CITY OF ALBUQUERQUE

**RE: Beyond Health Office Building
3700 Bosque Plaza Lane NW
Grading and Drainage Plan
Engineer's Stamp Date: 08/11/20
Hydrology File: E12D006H**

Based upon the information provided in your submittal received 08/17/2020, the Grading and Drainage Plan is approved for Building Permit.

Sheet Title
Grading Plan

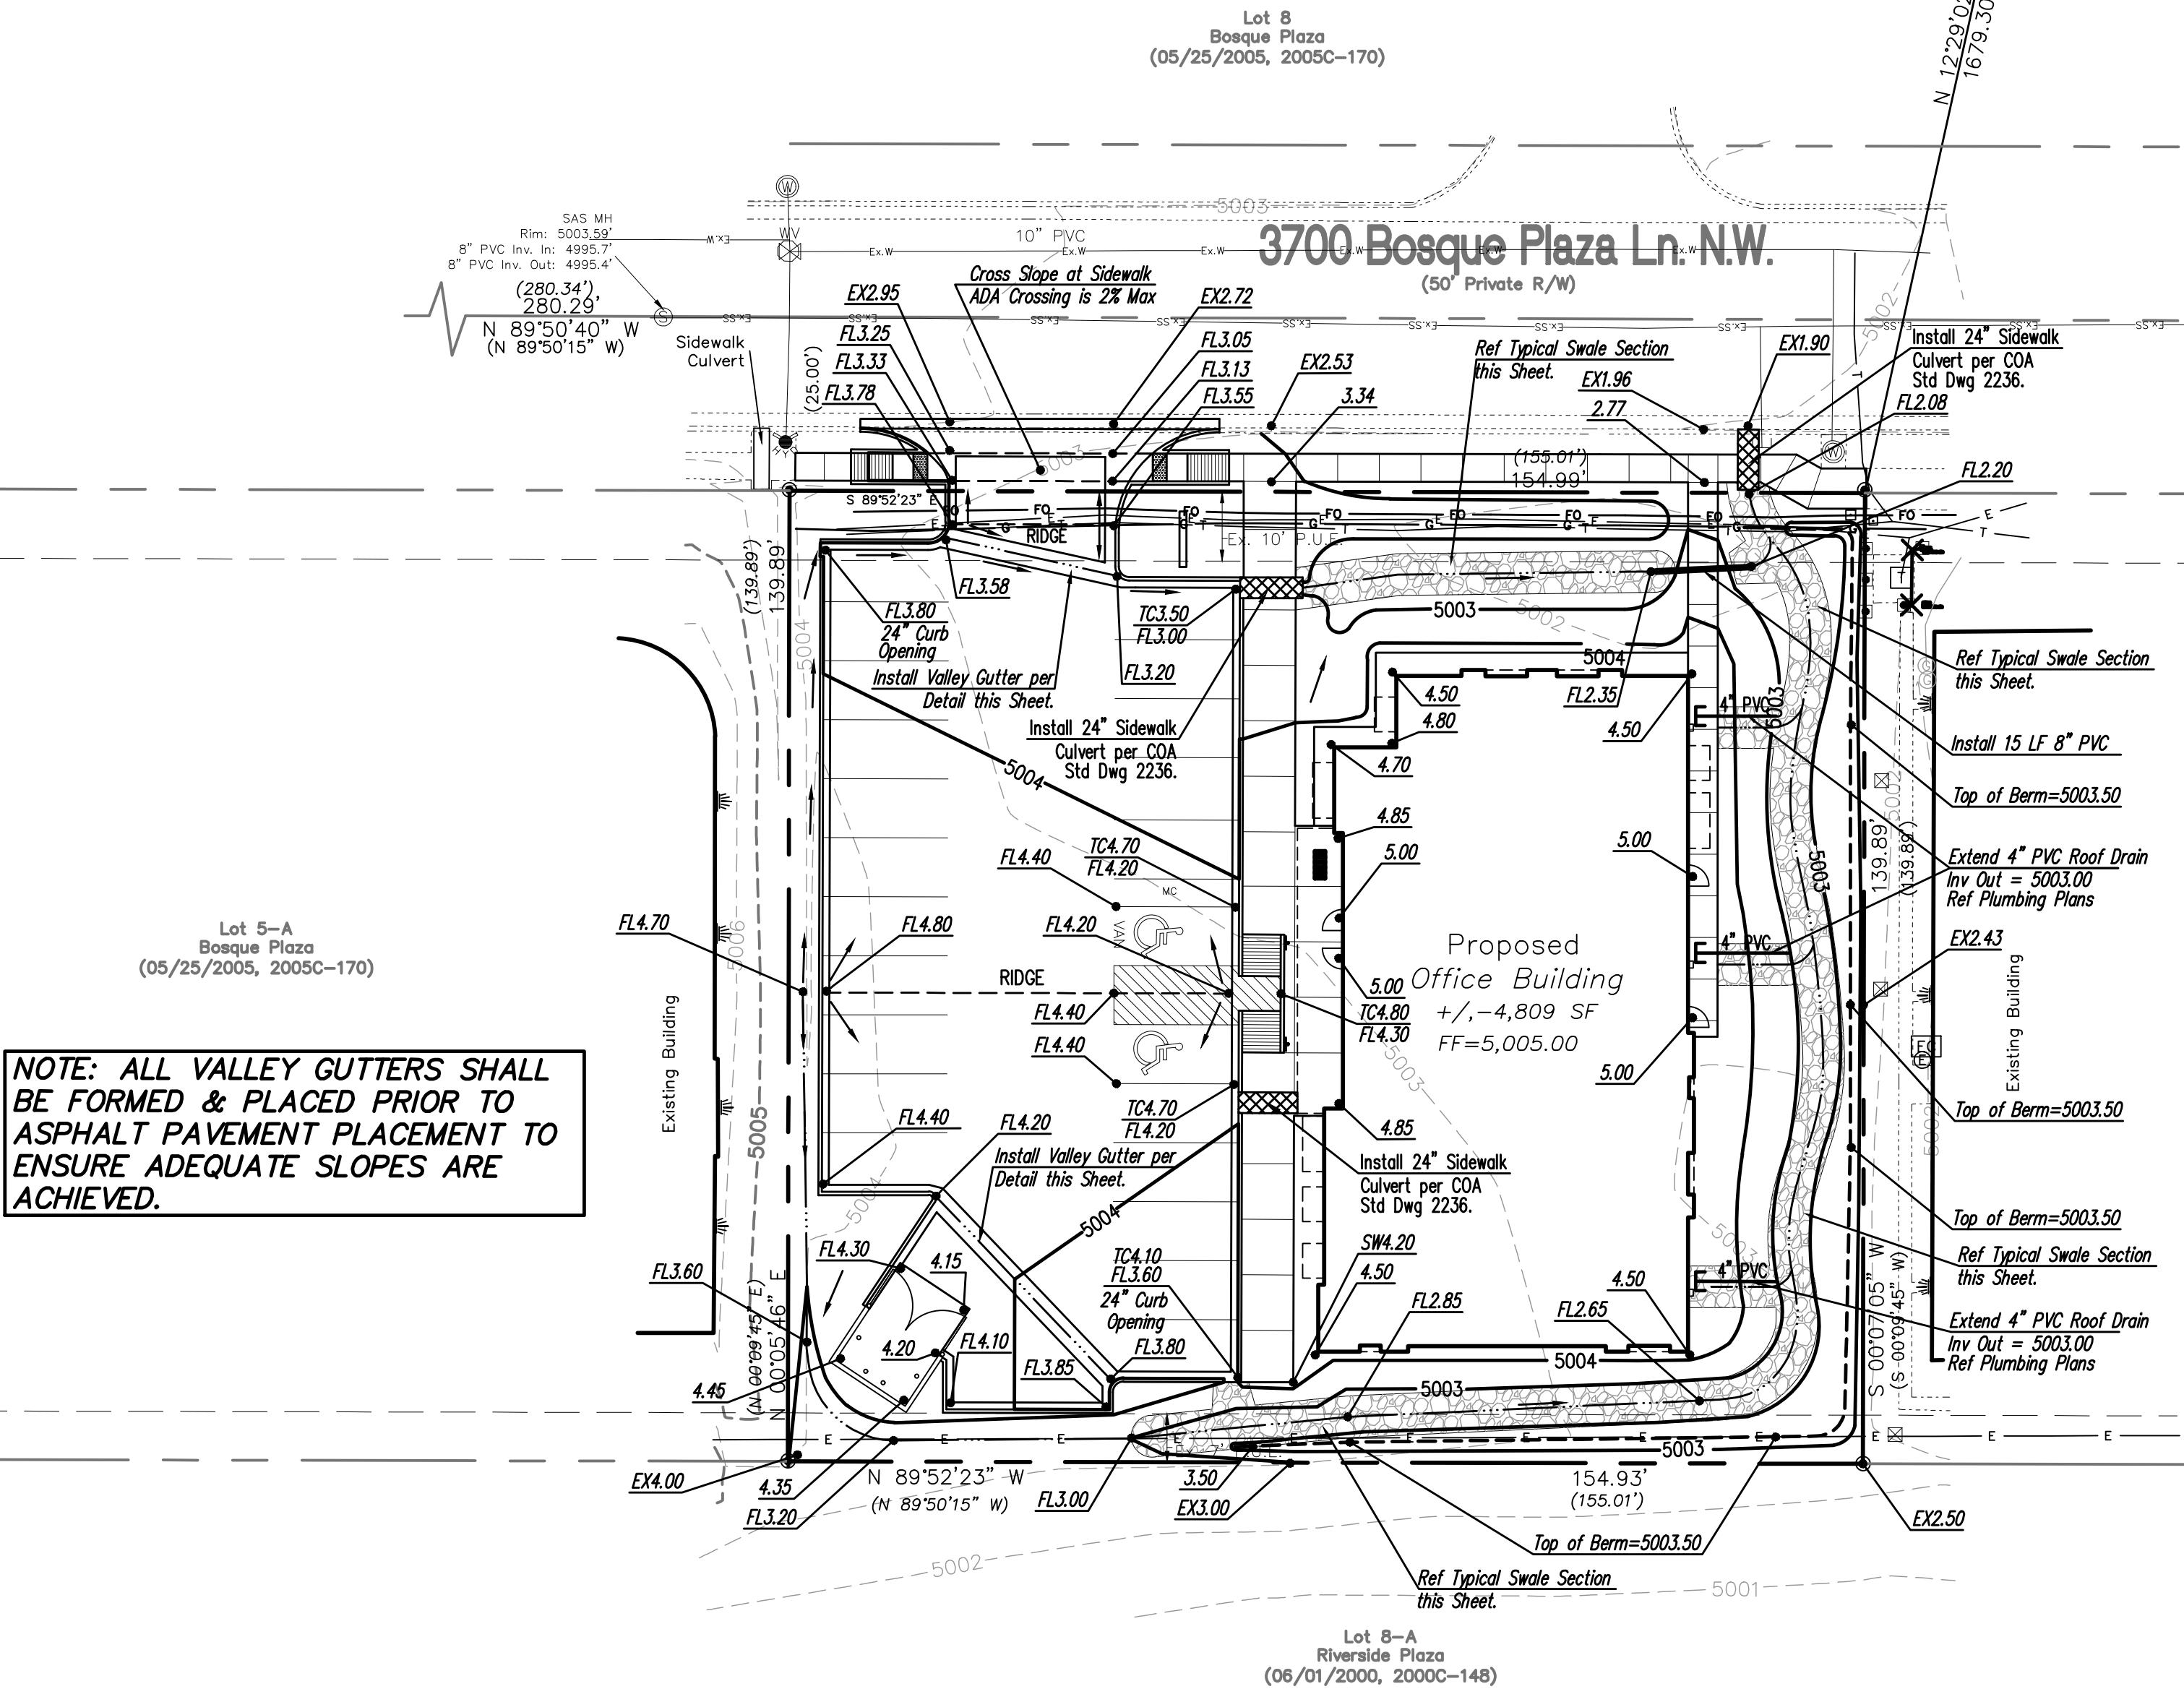
Please attach a copy of this approved plan in the construction sets for Building Permit processing along with a copy of this letter. Prior to approval in support of Permanent Release of Occupancy by Hydrology, Engineer Certification per the DPM checklist will be required.

Also as a reminder, please pay the Payment-in-Lieu for the stormwater quality pond volume required prior to Hydrology's approval in support of Permanent Release of Occupancy. The Payment-in-Lieu payment (Amount = 392 CF x \$8/CF = \$3,136.00). Please use the attached City of Albuquerque Treasury Deposit form. The Owner needs to bring three copies to the Building Permits and pay the fee.
